**MINOR VARIANCE APPLICATION
COMMENTS TO THE COMMITTEE OF ADJUSTMENT
PANEL 2**

Site Address: 1558 Baseline Road
Legal Description: Lot 2589 and Part of Lot 2590, Registered Plan 375
File No.: D08-02-23/A-00182
Report Date: September 16, 2023
Hearing Date: September 19, 2023
Planner: Samantha Gatchene
Official Plan Designation: Outer Urban Transect, Mainstreet Corridor
Zoning: R2F

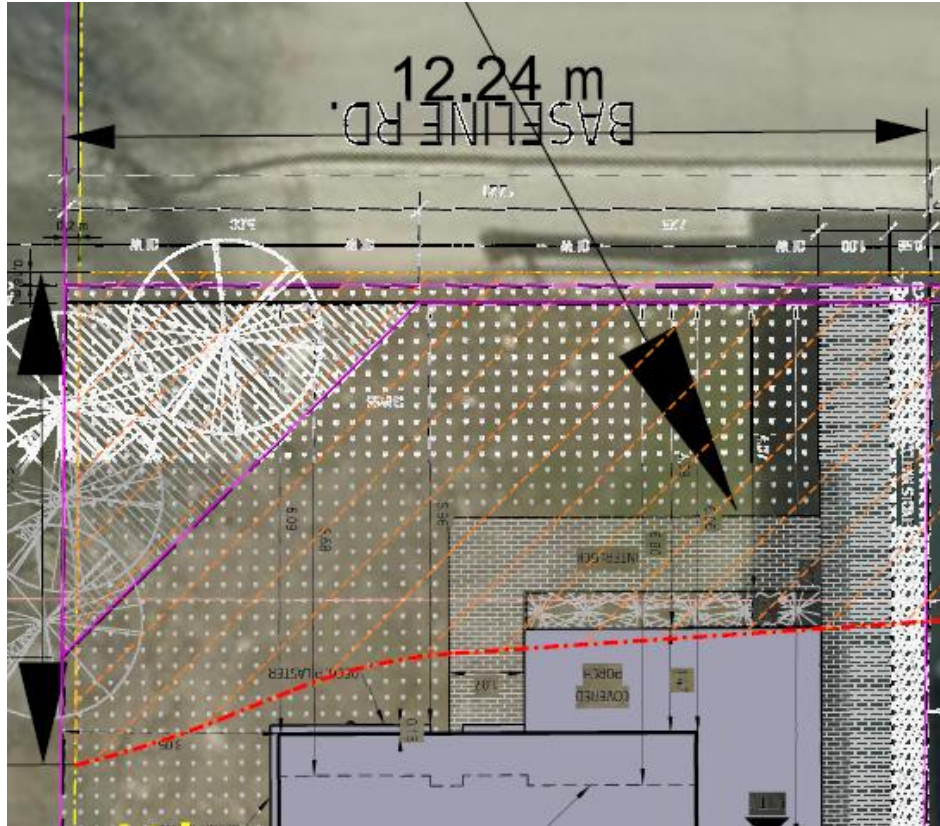
The development plans must show the required ROW widening/protection of Baseline Road as identified by the latest detailed design of the Baseline Transitway (Baseline Station to Heron Station) project. Contact Jabbar Siddique (jabbar.siddique@ottawa.ca) for a CAD file of the exact ROW requirements.

The proposed covered porch conflicts with the ROW requirements and would encroach onto the future sidewalk. Refer to the image below overlaying the proposed development with the Baseline Transitway ROW requirements (red line).

Construction of the development as planned would result in additional cost to the

Baseline Transitway project and disruption to the future owner when the proposed porch would need to be demolished and relocated to acquire the ROW required for the Baseline Transitway improvements. Transportation Planning therefore does not support the plans provided as part of the application, specifically the covered porch projection.
